**SITE PLAN REVIEW
PUBLIC HEARING**

REPORT TO THE DEVELOPMENT REVIEW COMMISSION FROM DEVELOPMENT REVIEW SERVICES DIVISION, PLANNING & ECONOMIC DEVELOPMENT DEPARTMENT, for Public Hearing and Executive Action on **May 4, 2022 at 1:00 P.M.** in Council Chambers, City Hall, 175 Fifth Street North, St. Petersburg, Florida.

CASE NO.: 22-31000002 PLAT SHEET: H-2

REQUEST: Approval of a site plan to construct a 19-story building with 244-dwelling units and a 256-space parking garage, located at 1641 and 1659 1st Avenue North. The applicant is requesting floor area ratio bonuses and building height bonus.

SITE PLAN
17TH/1ST AVE N ST.PETE TOWER

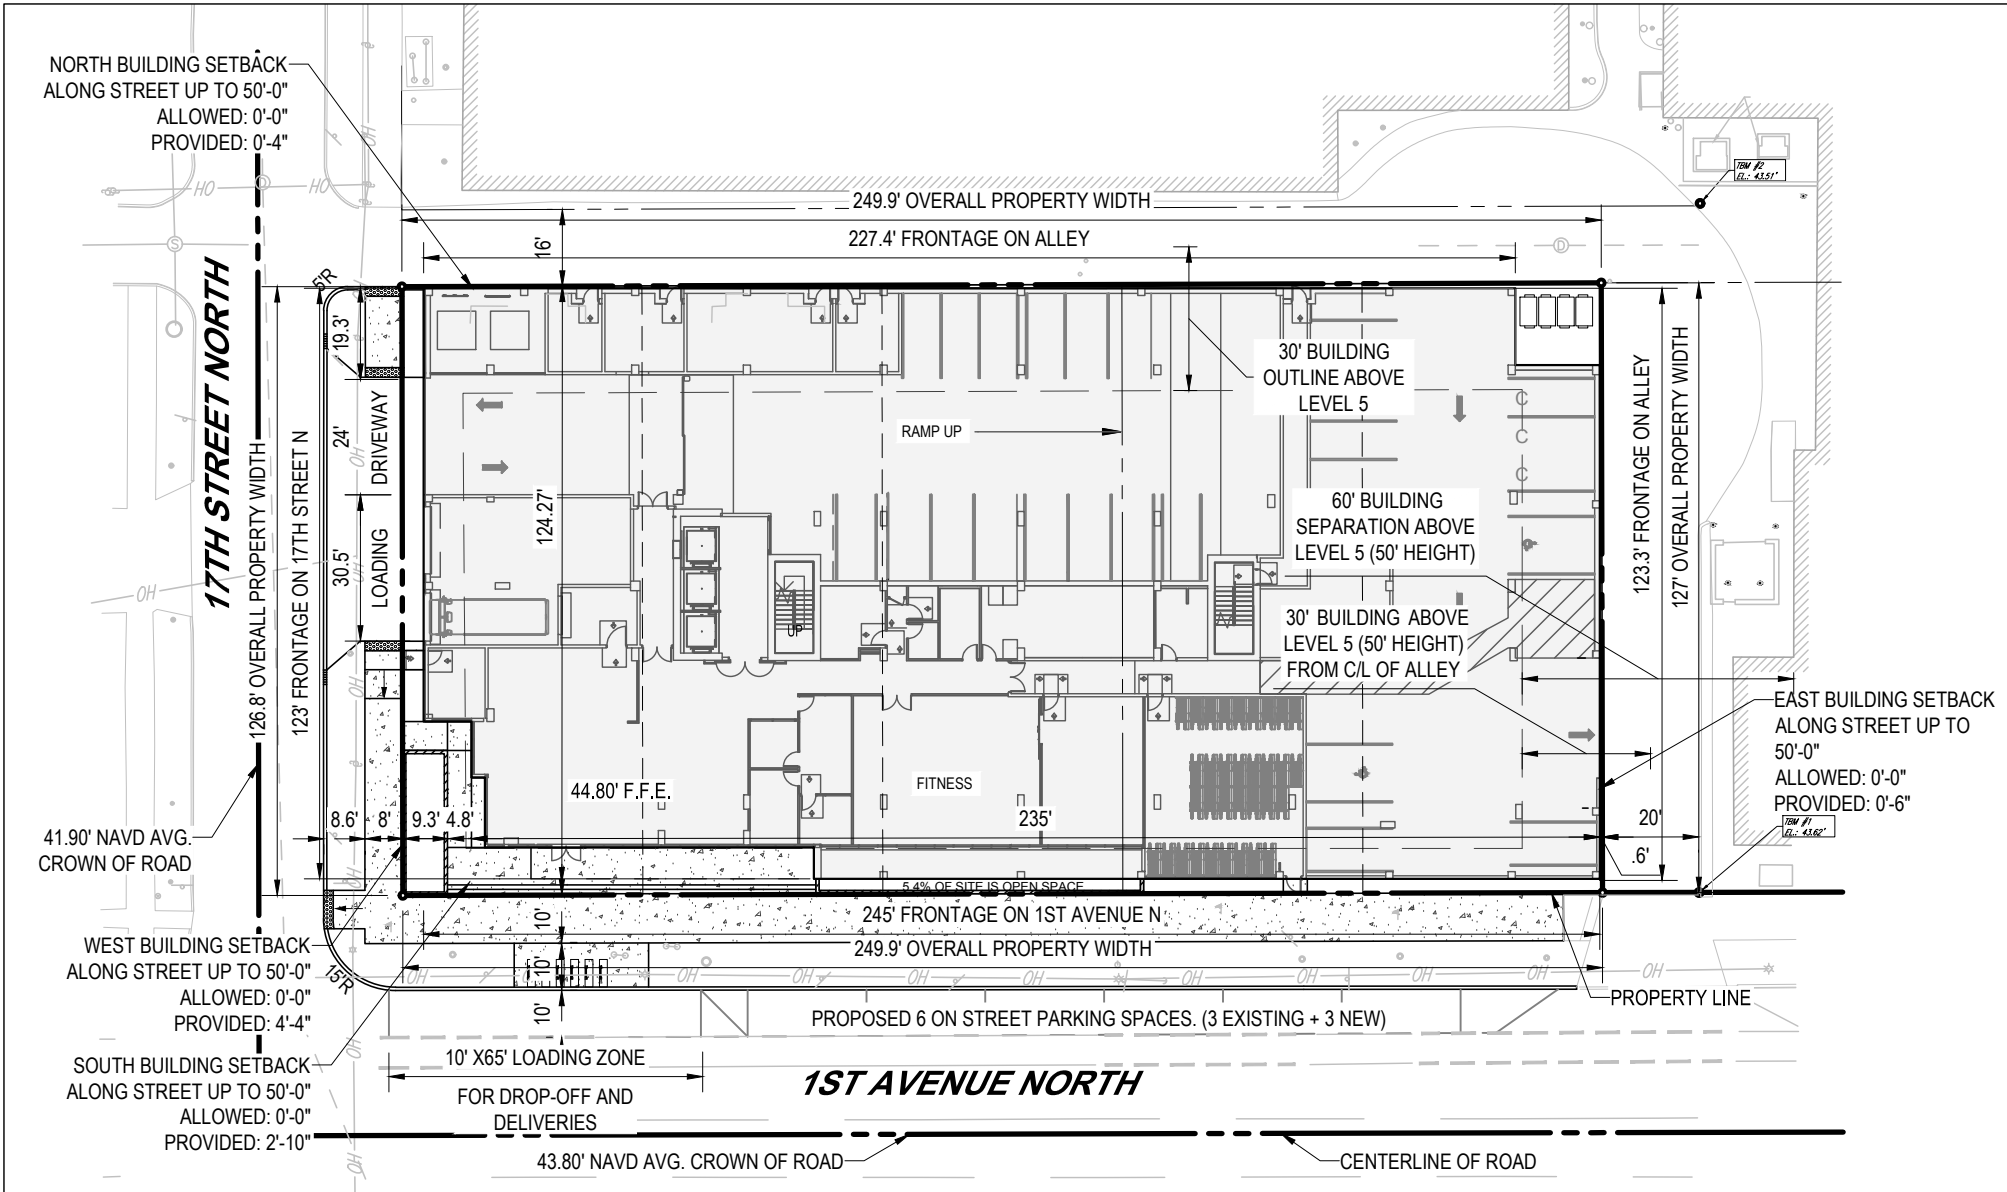
A loading zone is shown on 1st Avenue North east of 17th Street. The City's Engineering and Capital Improvements Department's "FY22 Resurfacing Project No. 22003-130" plans show the removal of on-street parking 70 feet back from the intersection. The proposed new parking spaces further to the east may be feasible since the surface parking lot would be removed.

The applicant is not required to provide a public sidewalk neck-out (bulb out) under Section 16.20.120.8 of the City Code because the proposed development is less than half a block. The applicant will be required to pay a multimodal impact fee (MIF) if the development is approved and built. If the applicant chooses to construct a bulb out at the intersection of 1st Avenue North and 17th Street after further discussions with the Transportation Department, they would receive a MIF credit for the additional cost of constructing the bulb out in comparison to Code-required sidewalk and curb improvements. If a curb ramp is not provided on the northern side of 1st Avenue North for the eastern 17th Street crossing of 1st Avenue North, the existing ramp on the southern side of 1st Avenue North shall be removed.

Under Section 16.40.140.4.2 of the City Code, 10-foot-wide sidewalks are required on 1st Avenue North and 17th Street because the subject property is in a DC-2 zoning district. It is evident that the applicant has provided a 10-foot-wide sidewalk on 1st Avenue North but it is not evident that the sidewalk on 17th Street is 10 feet wide.

- 5. Any modifications to the travel lane, parking spaces and landscape islands surrounding the subject property shall be subject to approval by the City.**

- 6. Concrete driveways shall be continuous through all driveway approaches and truncated domes shall be installed.**
- 7. The final streetscape and hardscape plan for the abutting streets shall be approved by Staff.**

14. The Construction Action Plan (CAP) shall be submitted to Zoning Official for review and approval prior to the issuance of building permits.
15. The site plan shall be modified as necessary to comply with the comments in the Transportation and Parking Management Department's Memorandum dated April 12, 2022, or as amended at a future date by the Transportation and Parking Management Department.

SOUTH ELEVATION

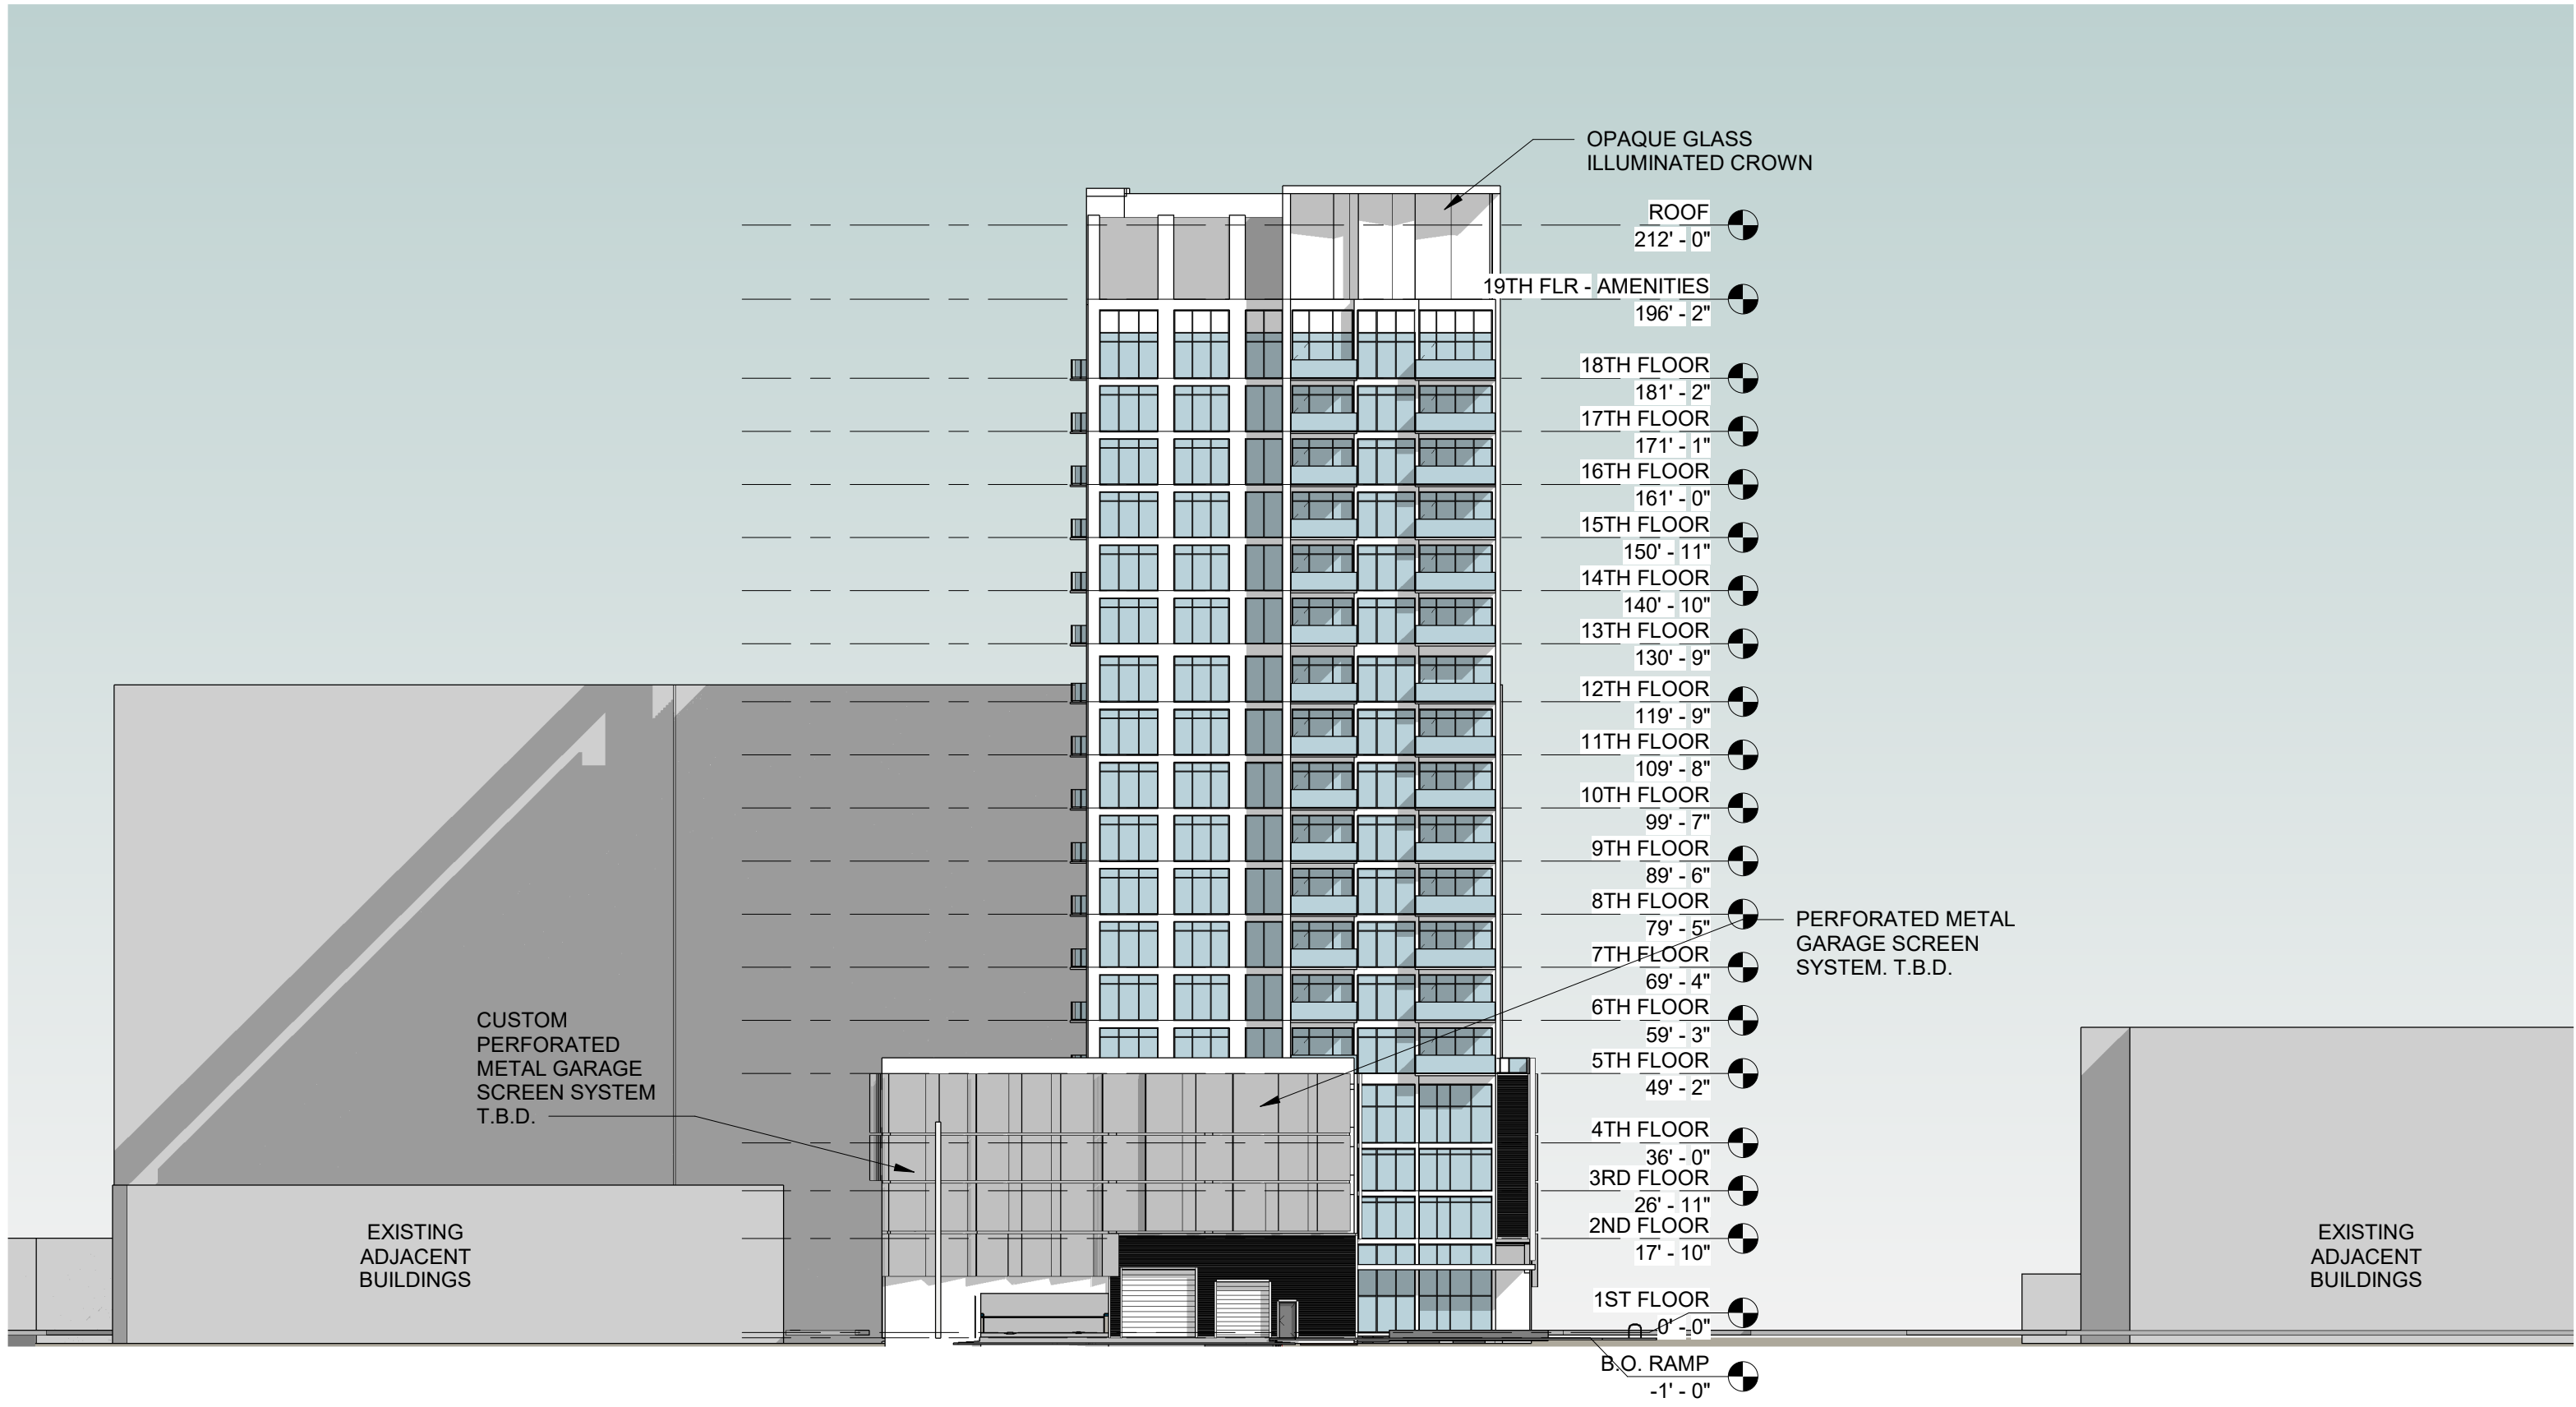
- 4. The applicant shall install a decorative crown to receive the additional building height. The final design shall be subject to approval by staff.**

- 8. The final design of the parking garage screening shall be approved by staff.**
